UNITED STATES PATENT AND TRADEMARK OFFICE

APPLICATION NO.	FILING DATE	FIRST NAMED INVENTOR	ATTORNEY DOCKET NO.	CONFIRMATION NO.
10/537,155	05/31/2005	Sung Hwa Lee	0465-1352PUS1	1452

Office Action Summary

DETAILED ACTION

Appendix A

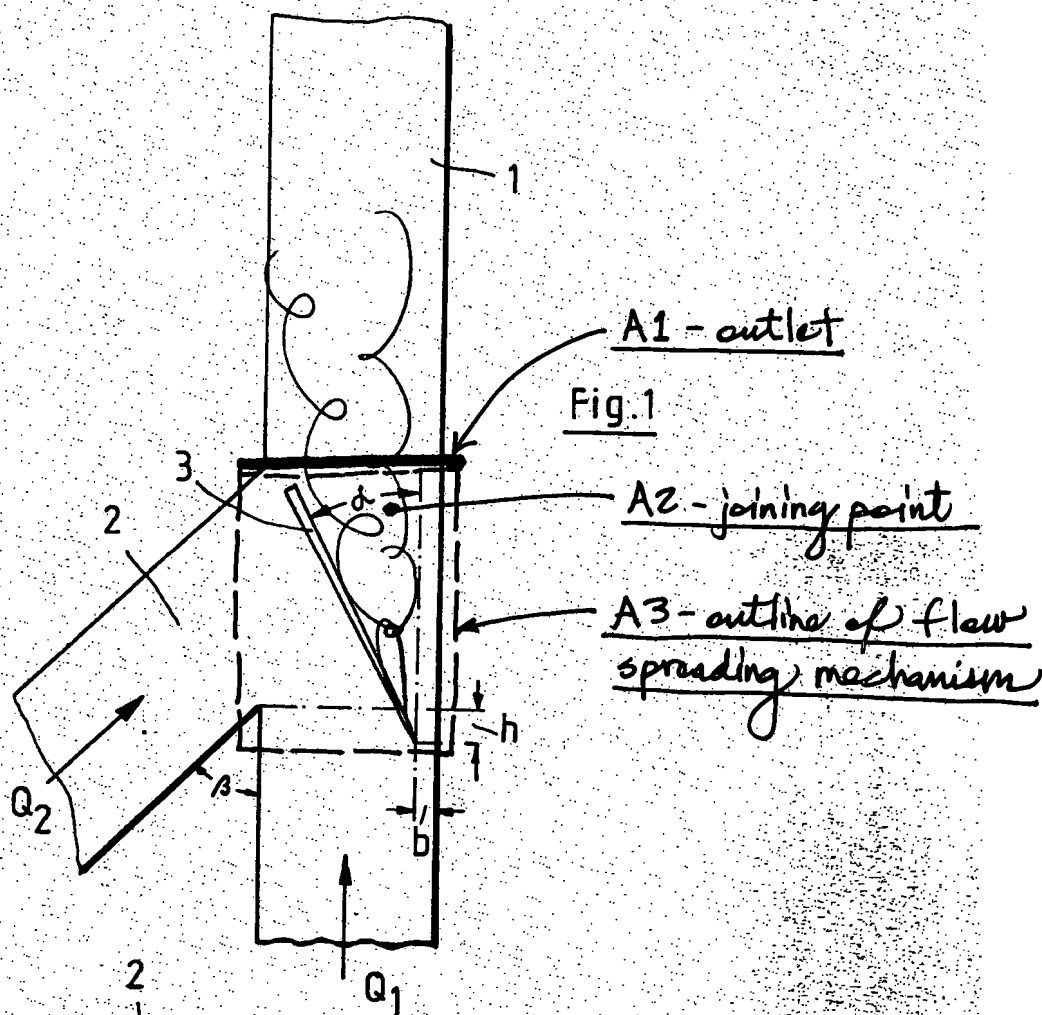
10. Specifically, in regard to amended claim 1, which is directed to a flow spreading mechanism, Ruscheweyh '786 discloses at least one inlet (inlet to feed conduit 2) through which a fluid flow (individual stream Q_2) is introduced; a flow separating means (delta-shaped insert element 3) for separating the fluid flow introduced through the at least one inlet into at least two fluid flows (separate streams between the edges of the delta-shaped insert element 3 and the conduit walls); and an outlet (A1, as annotated in attached Appendix A) for discharging at least two of the at least two fluid flows to an outside of the flow spreading mechanism (A3, dashed outline in Appendix A), at least two fluid flows being divided by the flow separating means (3) and joined together at a joining point (A2, as indicated in Appendix A) thereafter, wherein the outlet (A1) is located adjacent to the joining point (A2) where the at least two fluid flows are joined together such that the fluid flow being discharged through the outlet (A1) swings while proceeding due to complex vortices caused by the at least two fluid flows being joined together at the joining point (A2). See Ruscheweyh '786, Figure 1; column 1, lines 24-38; column 4, lines 65-68; and column 5, lines 1-8; also see attached Appendix A (annotated version of Figure 1 in Ruscheweyh '786). Therefore, because all of the elements in claim 1 of this application are disclosed by the Ruscheweyh '786 reference, this claim is rejected in accordance with 35 U.S.C. 102(b).

11. In regard to claim 2, which depends upon claim 1, Ruscheweyh '786 further discloses that the flow separating means comprises a plurality of conduits (main conduit 1 and feed

conduit 2) for providing the flow introduced from the inlet with flow paths. Refer to Ruscheweyh '786, Figure 1; column 4, lines 65-68; and column 5, lines 1-8. Thus, Ruscheweyh '786 meets the language of this claim.

12. In regard to claim 3, which depends upon claim 2, Ruscheweyh '786 further discloses that the number of the inlets is the same as that of the conduits (both main conduit 1 and feed conduit 2 have separate inlets), and each inlet corresponds to each conduit (the inlet through which stream Q_1 is introduced corresponds to main conduit 1, whereas the inlet through which stream Q_2 is introduced corresponds to feed conduit 2). See Ruscheweyh '786, Figure 1; column 4, lines 65-68; and column 5, lines 1-8. Consequently, the Ruscheweyh '786 reference also meets the language set forth in claim 3.

13. In regard to claim 4, which depends upon claim 2, Ruscheweyh '786 further discloses that the flow separating means comprises two conduits (main conduit 1 and feed conduit 2). Refer to Ruscheweyh '786, Figure 1; column 4, lines 65-68; and column 5, lines 1-8. Therefore, Ruscheweyh '786 also meets the language set forth in this claim.

Appendix B

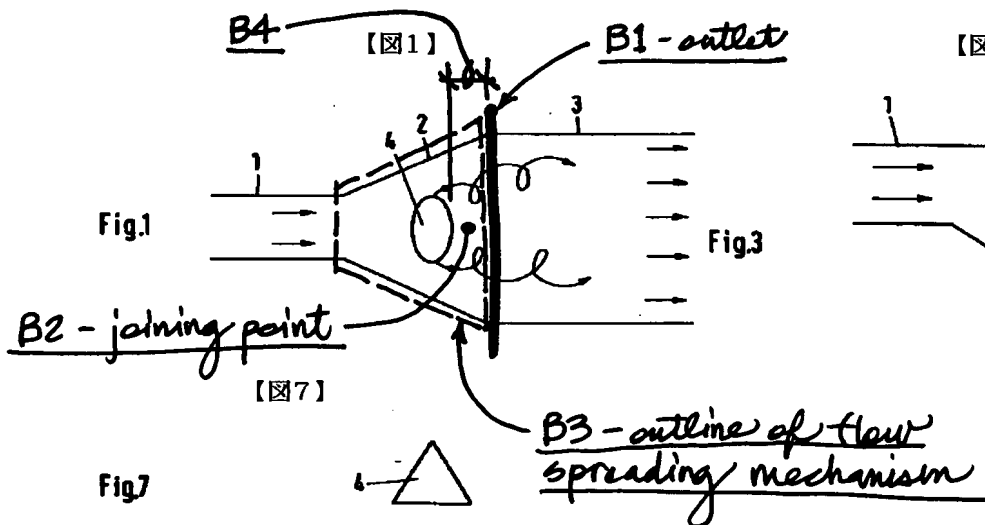
the edges of the ellipse or circular inclusion side 4 and the flow passage 2 walls); and an outlet (B1 at the beginning of outflow passage 3, as annotated in attached Appendix B) for discharging at least two of the at least two fluid flows to an outside of the flow spreading mechanism (B3, dashed outline in Appendix B), at least two fluid flows being divided by the flow separating means (4) and joined together at a joining point (B2, as indicated in Appendix B) thereafter, wherein the outlet (B1) is located adjacent to the joining point (B2) where the at least two fluid flows are joined together such that the fluid flow being discharged through the outlet (B1) swings while proceeding due to complex vortices caused by the at least two fluid flows being joined together at the joining point (B2). See Ruscheweyh '108, Figure 1; column 2, lines 41-50; column 3, lines 1-13; see also attached English translation of Ruscheweyh '108, paragraphs [0012-0014] and attached Appendix B (annotated version of Figure 1 in Ruscheweyh '108). Therefore, because all of the elements in claim 1 of this application are disclosed by the Ruscheweyh '108 reference, this claim is rejected in accordance with 35 U.S.C. 102(b).

20. In regard to new independent claim 22, Ruscheweyh '108 discloses all of the claimed elements, including: a conduit (2) having an inlet (inflow passage 1) and an outlet (B1 at the beginning of outflow passage 3, as annotated in attached Appendix B); and a blunt body (ellipse or circular inclusion side 4) placed inside the conduit (2) and configured to break an inlet fluid flow coming from the inlet (inflow passage 1) into at least two separate fluid flows (two streams

between the edges of the ellipse or circular inclusion side 4 and the flow passage 2 walls) and then join the at least two separate fluid flows at a joining point (B2, as indicated in Appendix B) thereafter into a discharge fluid flow discharged through the outlet (B1), wherein the outlet (B1) of the conduit (2) is located adjacent to the joining point (B2) where the at least two fluid flows are joined together such that the discharged fluid flow being discharged through the outlet (B1) swings while proceeding due to complex vortices caused by the at least two fluid flows being joined together at the joining point. See Ruscheweyh '108, Figure 1; column 2, lines 41-50; column 3, lines 1-13; see also attached English translation of Ruscheweyh '108, paragraphs [0012-0014] and attached Appendix B (annotated version of Figure 1 in Ruscheweyh '108). Therefore, because all of the elements in claim 22 of this application are disclosed by the Ruscheweyh '108 reference, this claim is rejected in accordance with 35 U.S.C. 102(b).

22. In regard to claim 26, which depends upon claim 23, Ruscheweyh '108 further discloses that distance (dimension B4 in Appendix B) between the blunt body (4) and the outlet (B1) is smaller than a width of the outlet (B1). See attached Appendix B (annotated version of Figure 1 in Ruscheweyh '108). Consequently, the Ruscheweyh '108 reference also meets the language set forth in claim 26.
